REFERENCE TO THE BOARD

**REVIEW OF TWO GENERATION
EXPANSION OPTIONS FOR THE
LEAST-COST SUPPLY OF POWER TO
ISLAND INTERCONNECTED CUSTOMERS
FOR THE PERIOD 2011 – 2067**

REPORT TO GOVERNMENT

NEWFOUNDLAND AND LABRADOR
BOARD OF COMMISSIONERS OF PUBLIC UTILITIES

Preliminary HVdc Link Expansion Plan vs. Load Forecast

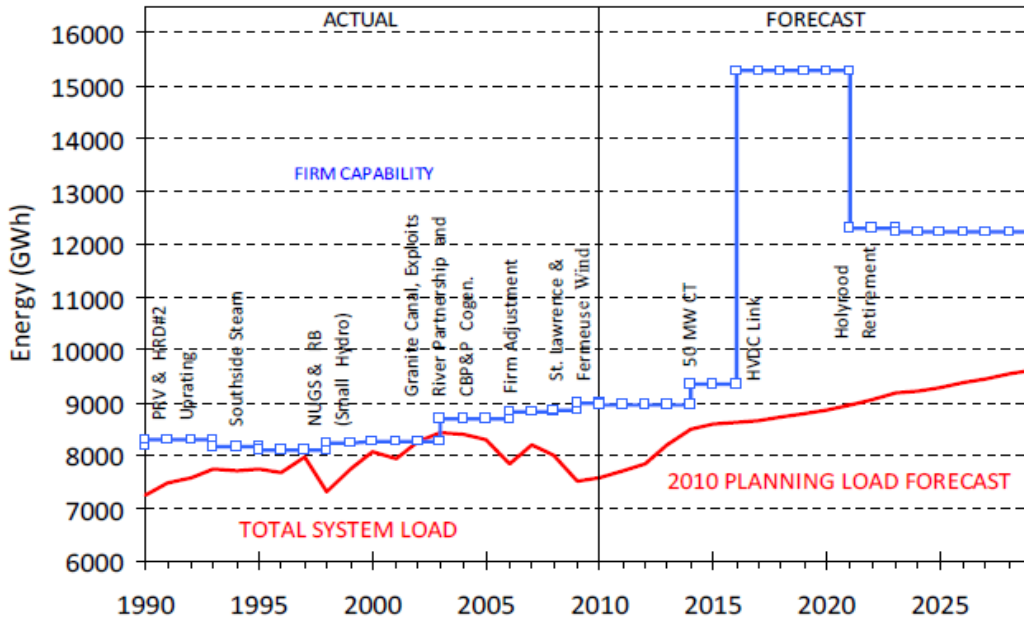
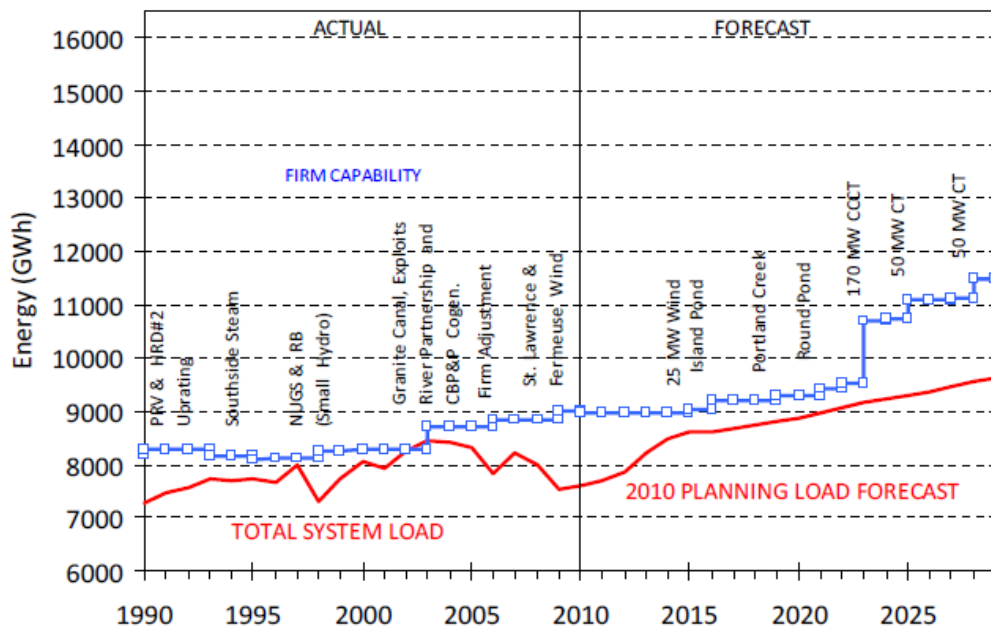
In relation to how the 2010 Planning Load Forecast relates to system capability, the Board refers to the comparison graphs of forecasted load and system capability set out above. The first graph shows the forecast energy shortfall in 2021. The next two graphs show how the two options will meet the forecast load. The Interconnected Option involves a very large incremental increase in generation capability and a significant amount of excess energy and capacity until well beyond the 20-year planning period. This graph highlights the significance of the assumption required by the Terms of Reference that the excess power is not monetized or utilized. As shown in the third graph the Isolated Island Option offers what might be considered a less risky approach more in line with principles of distributed generation, where capacity and energy are added in smaller increments more closely matching the load forecast.

These graphs show that there is not an immediate need for the large incremental supply associated with the Interconnected Option and that Island electricity needs could be met in the short to medium term with available renewable sources on the Island and/or additional thermal generation. It appears that avoidance of fuel costs is a critical factor in this generation planning decision. Nalcor's analysis shows that the Interconnected Option is least-cost primarily as a result of the avoided fuel costs associated with the closure of the Holyrood Thermal Generating Station.
